*PLANS FOR THE CONSTRUCTION OF
SEDIMENT REMOVAL
FOR
VITRUVIAN PARK
TOWN OF ADDISON, TEXAS
PUBLIC WORKS #19-77*

VITRUVIAN PARK
 DREDGING
 TOWN OF ADDISON
 DALLAS COUNTY, TEXAS

revisions	date
1 ADDENDUM 3	2/20/2019

MAIN CHANNEL CROSS SECTIONS					Sheet No.
design	drawn	checked	scale	date	11
NDM	NDM	NDM	NDM	2/20/19	22
NDM job number					18-005

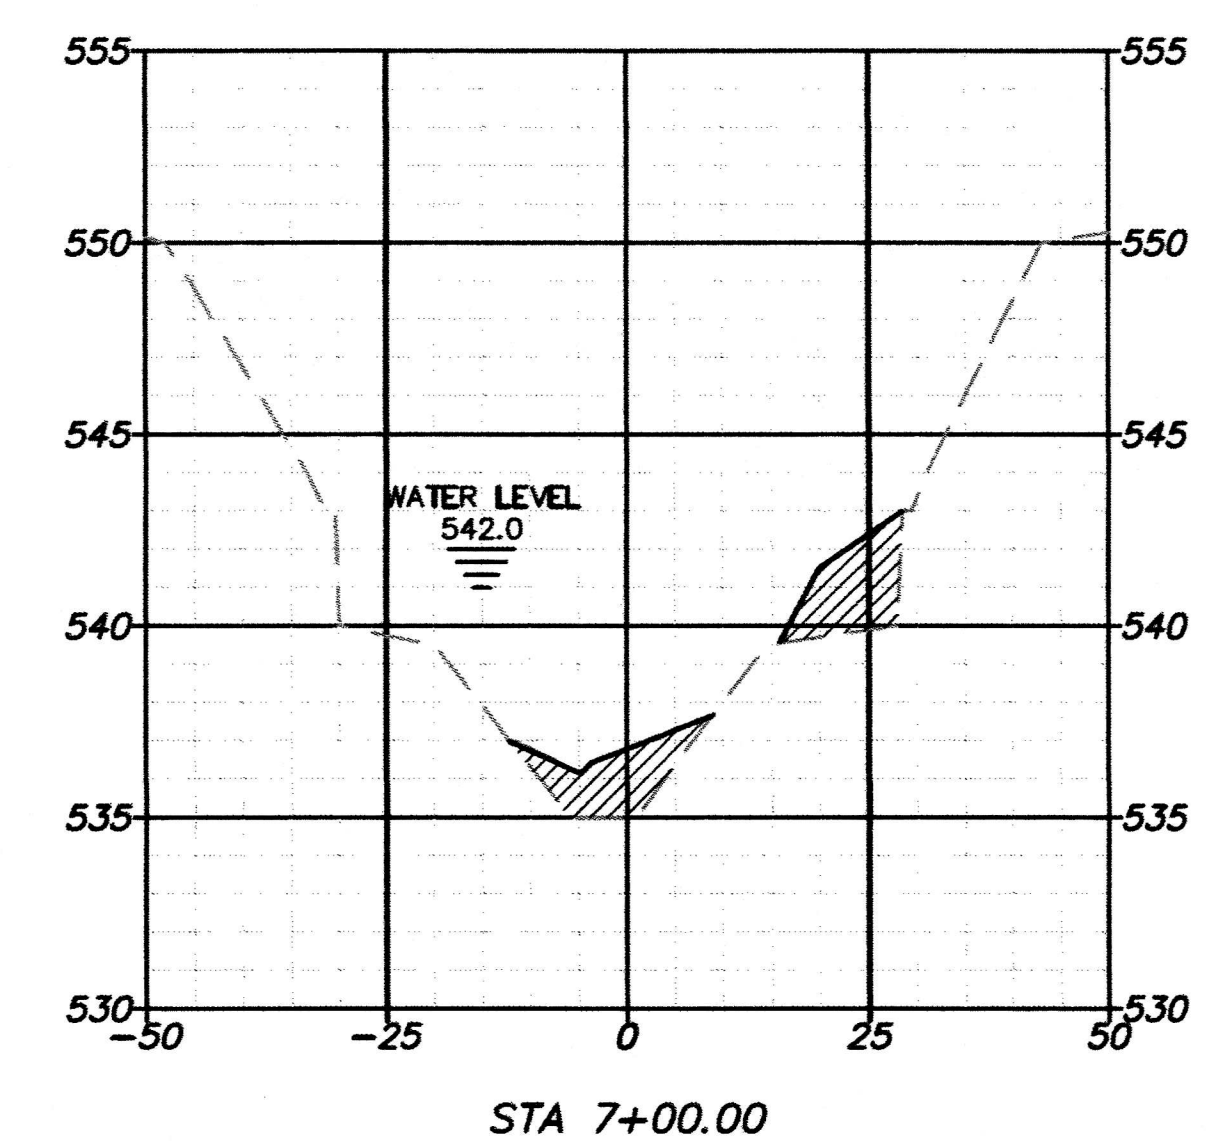
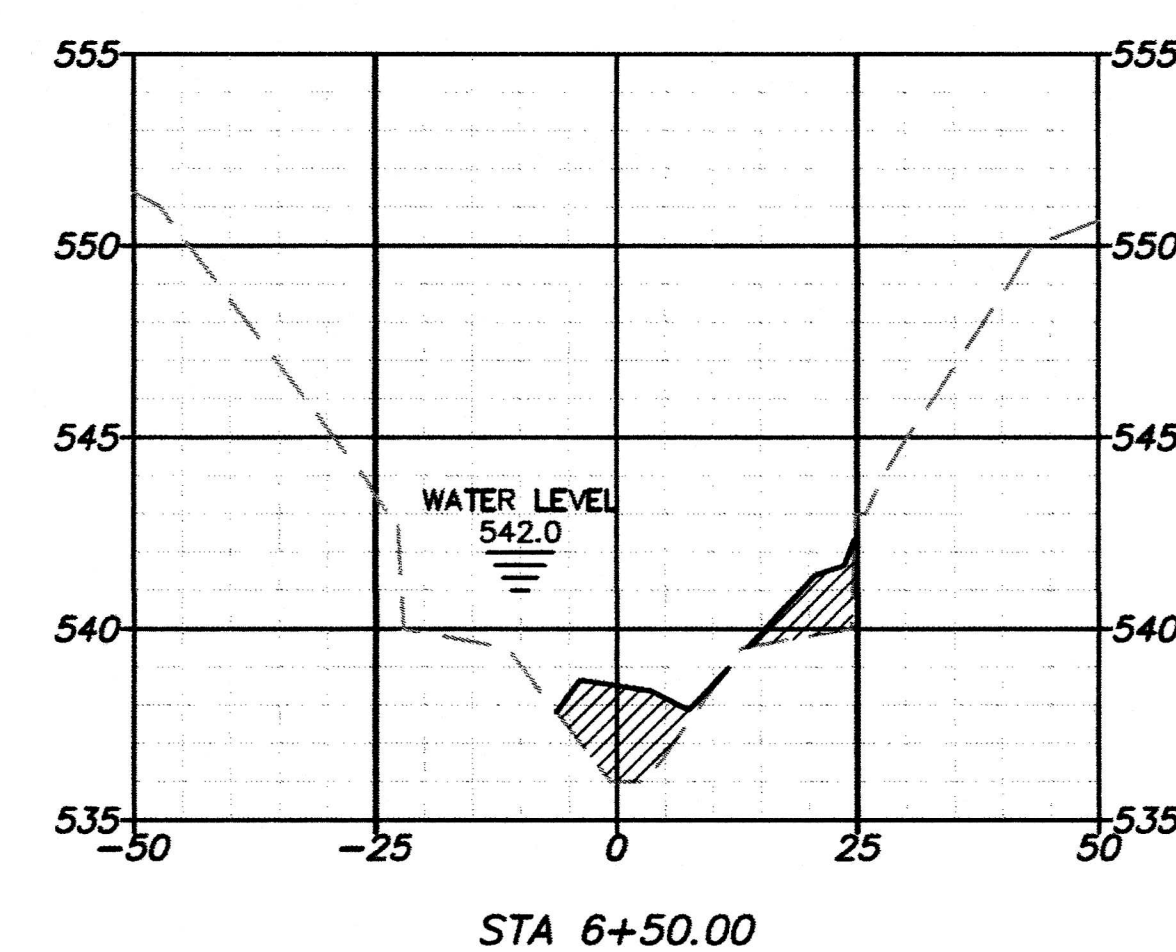
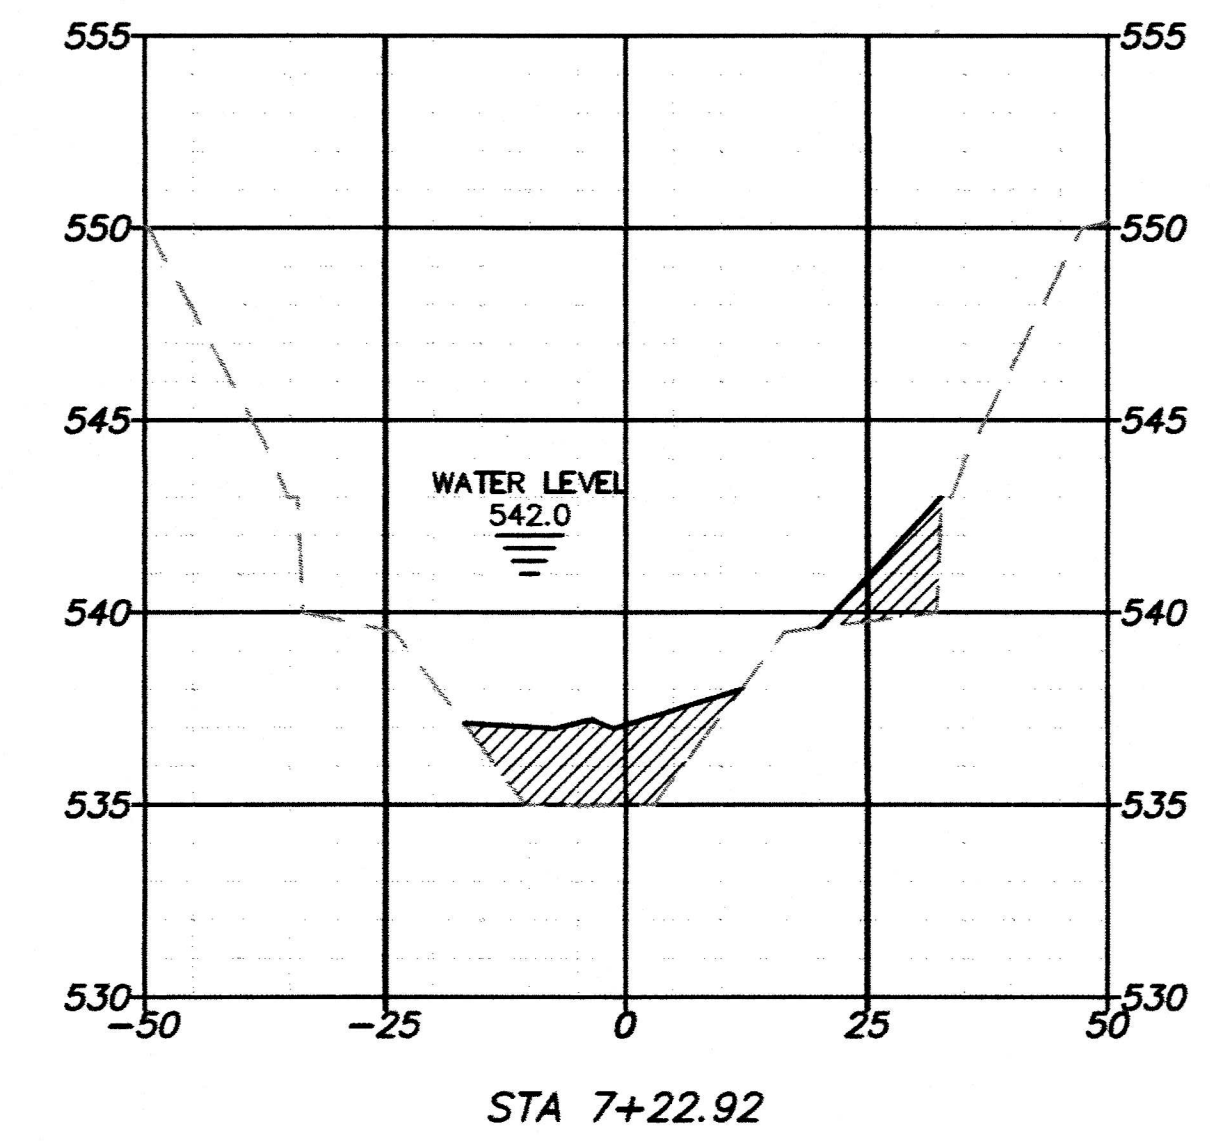
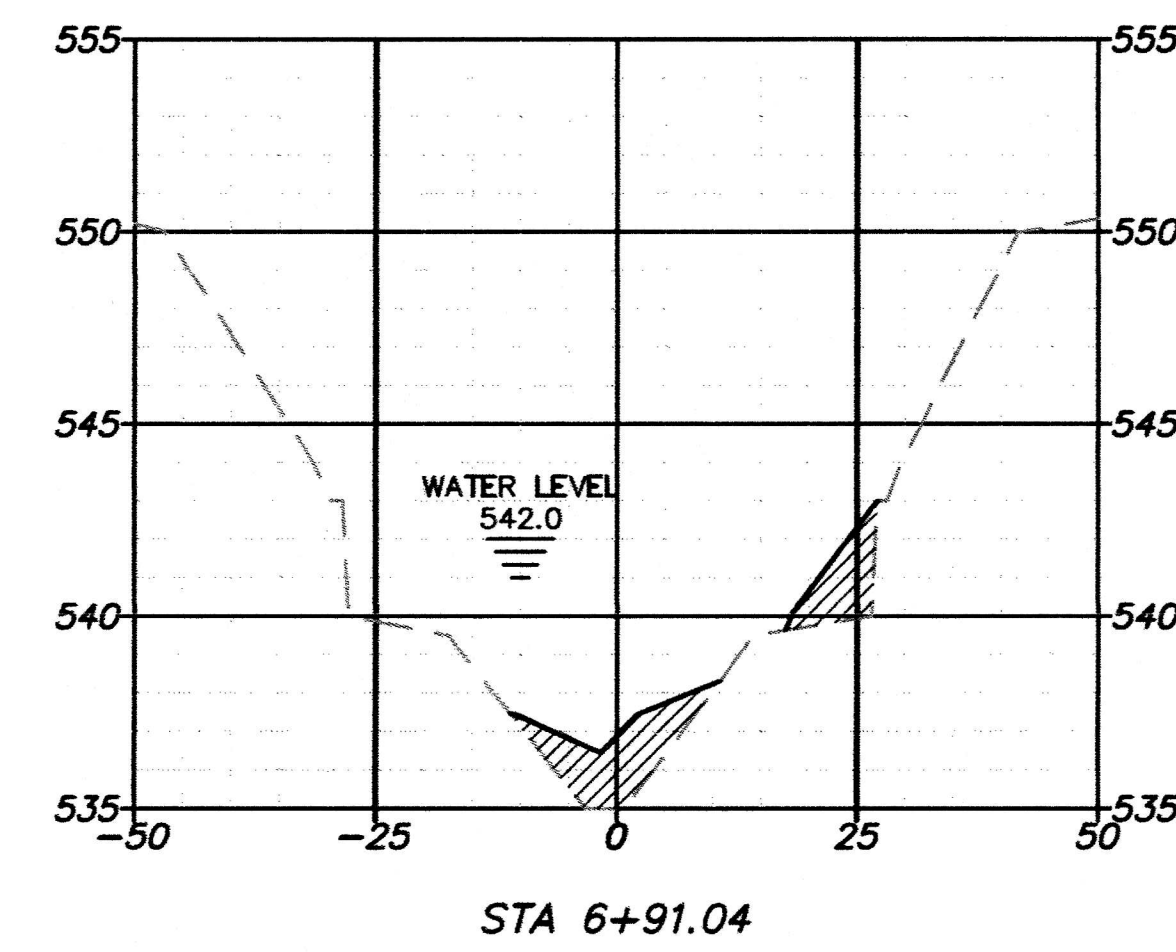
William L. Wallace
 2-20-19
 WATER SURFACE ADDED BASED ON SURVEY OF 2/18/2019.

MAIN CHANNEL CROSS SECTIONS				
design	drawn	checked	scale	date
NDM	NDM	NDM	NDM	2/20/19

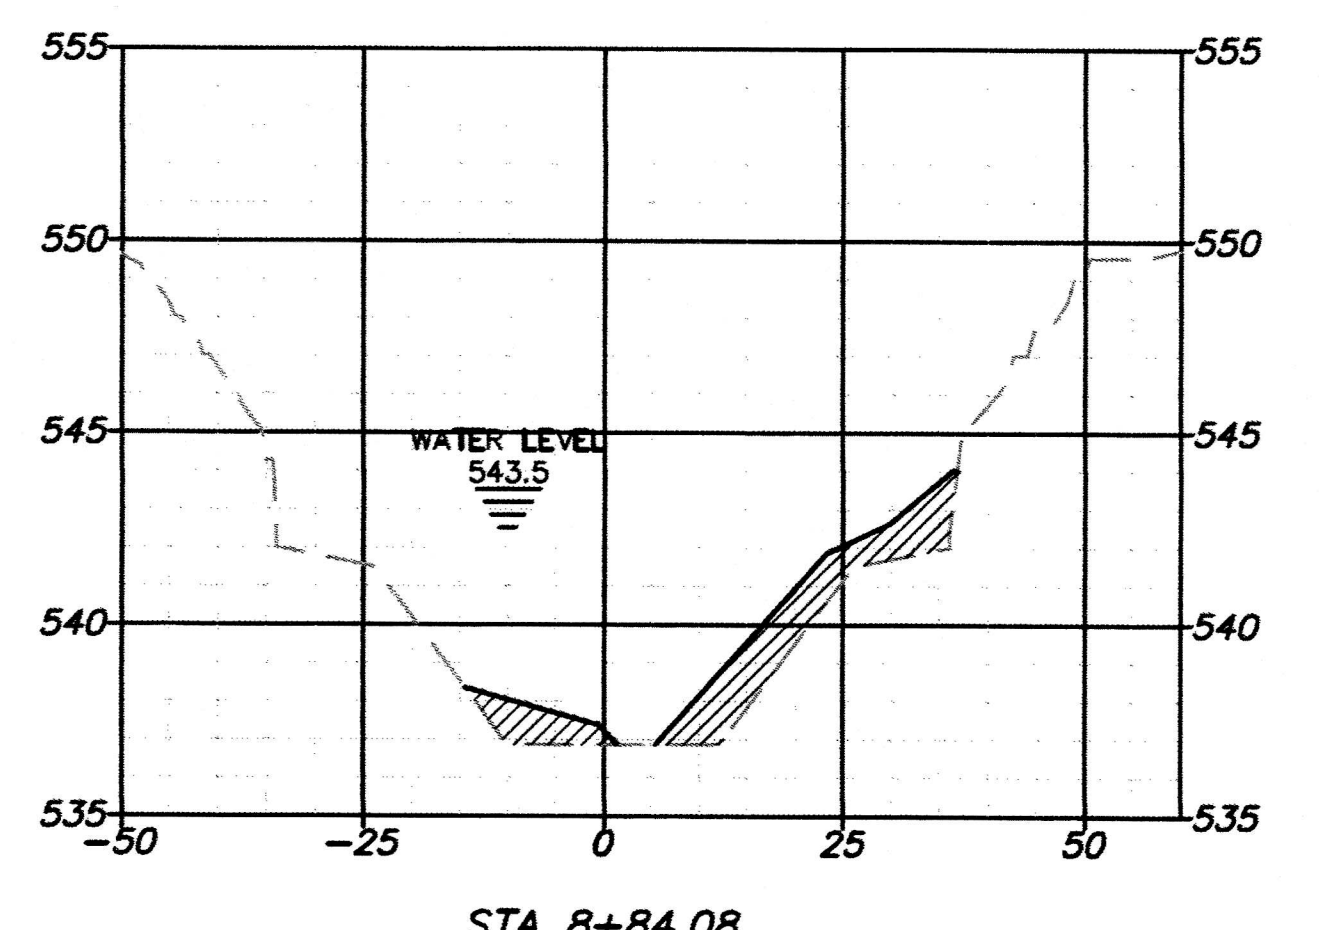
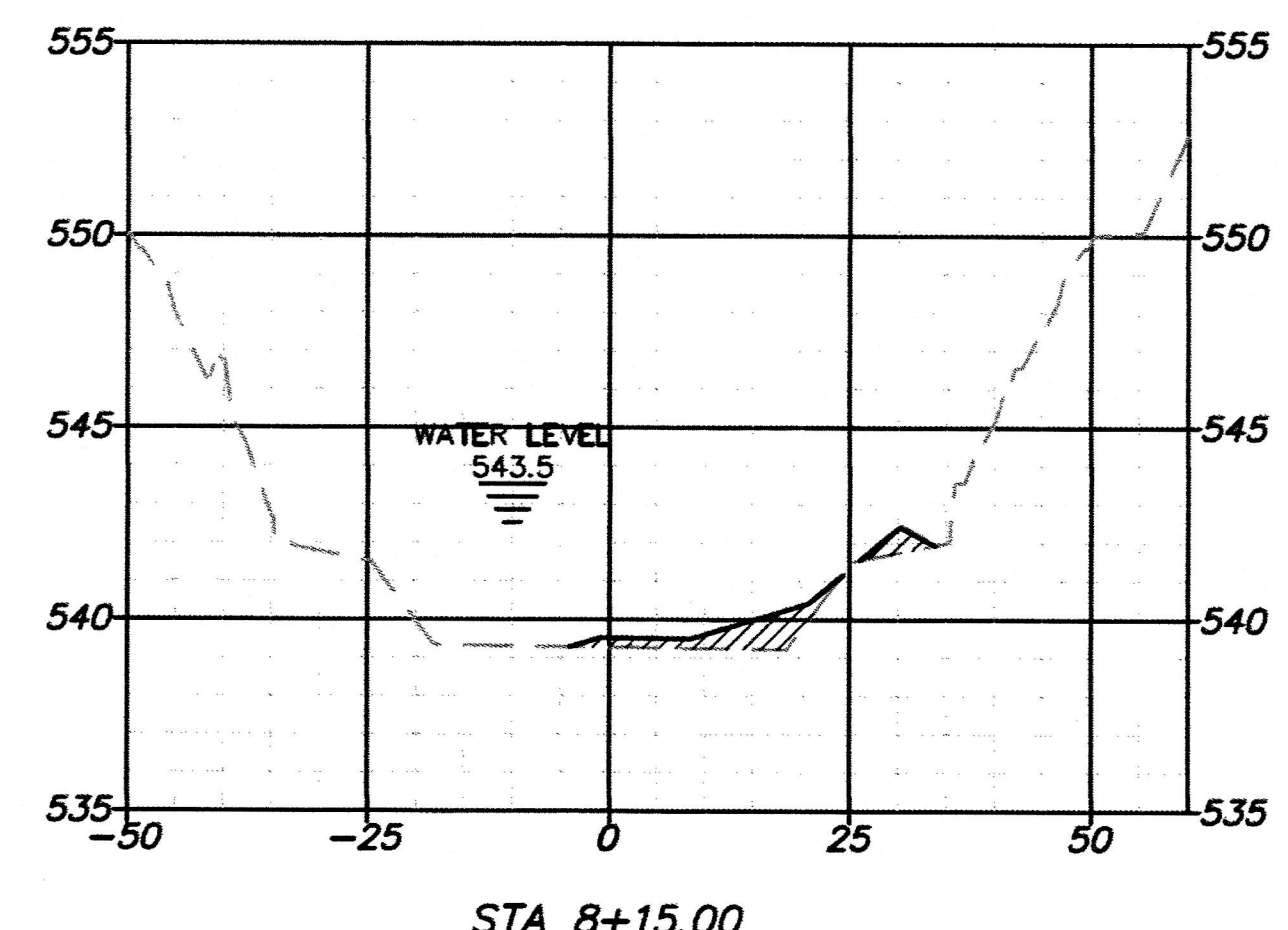
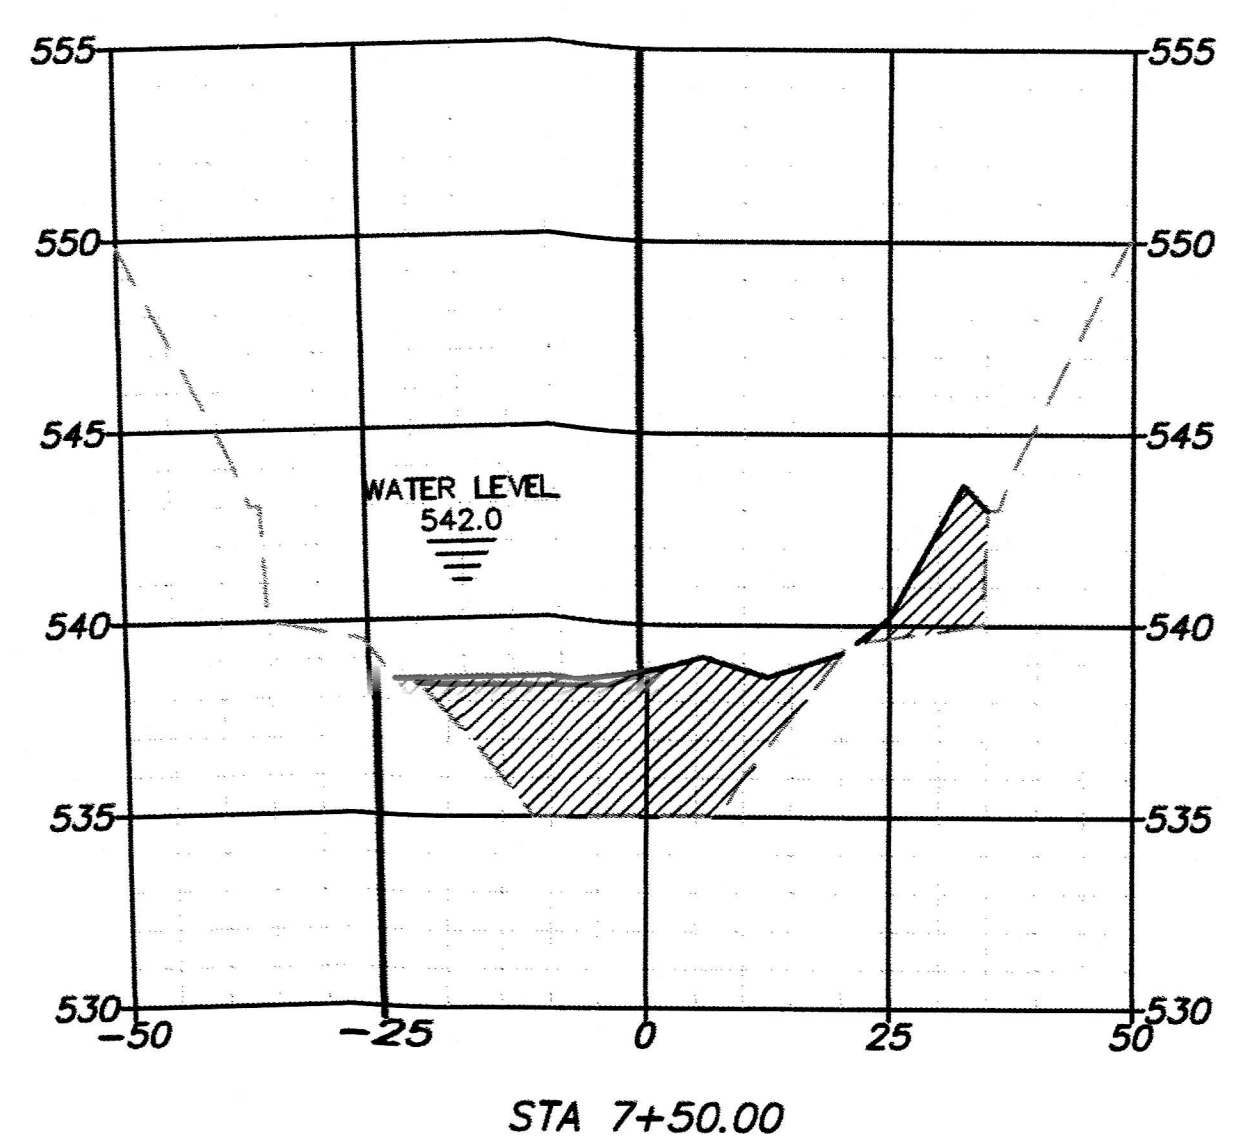
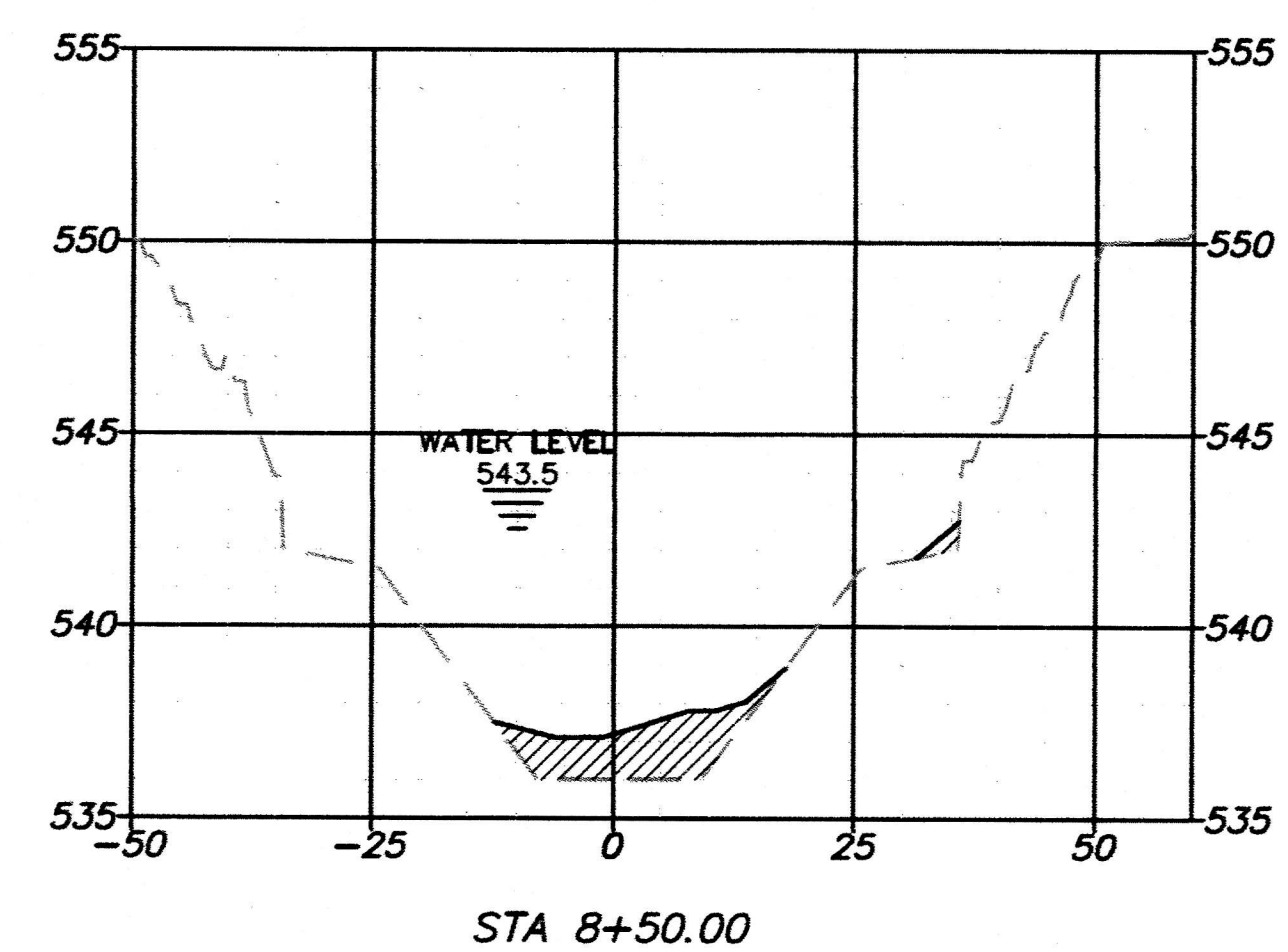
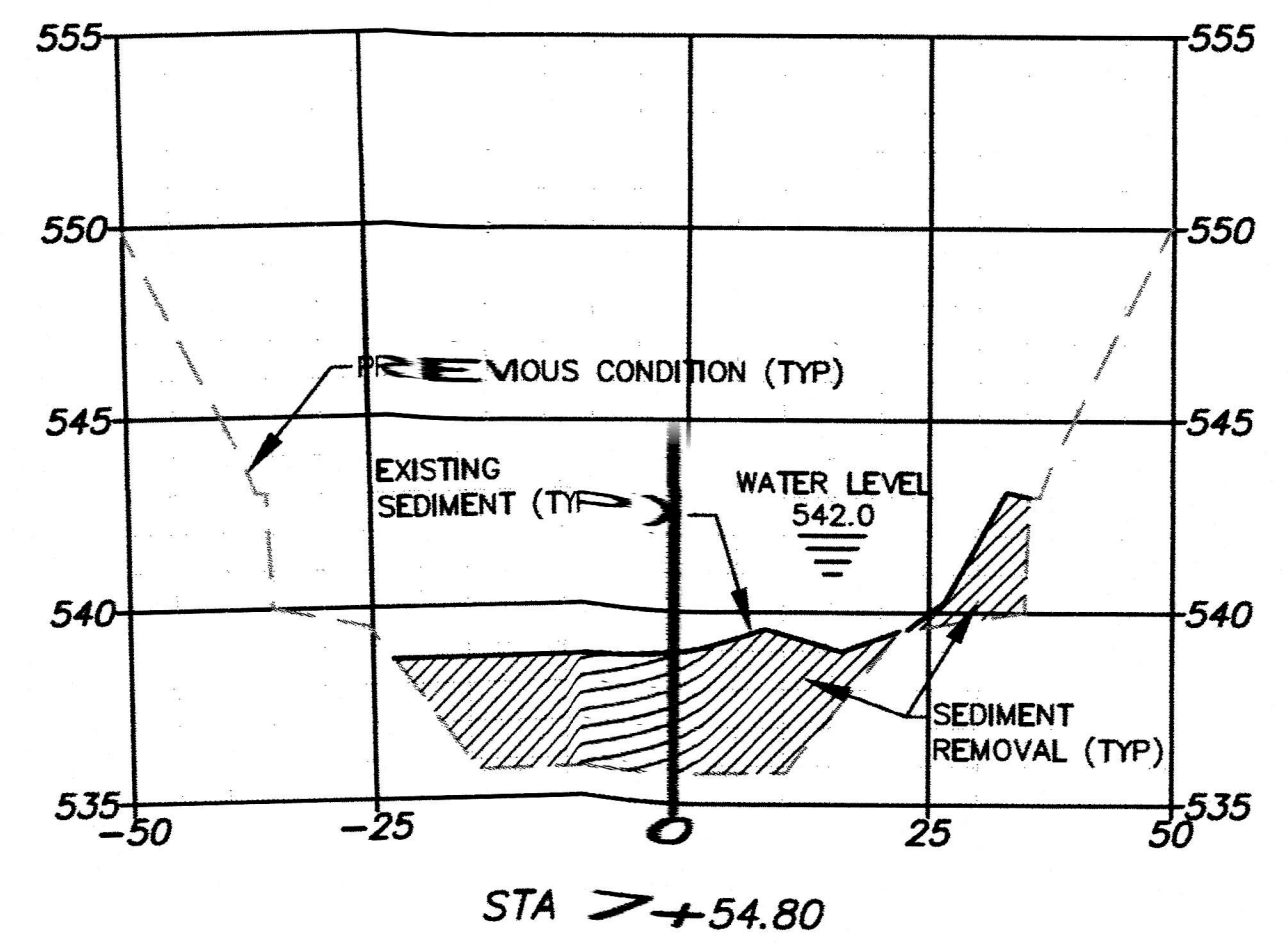
▲ WATER SURFACE ADDED BASED ON SURVEY OF 2/18/2019.
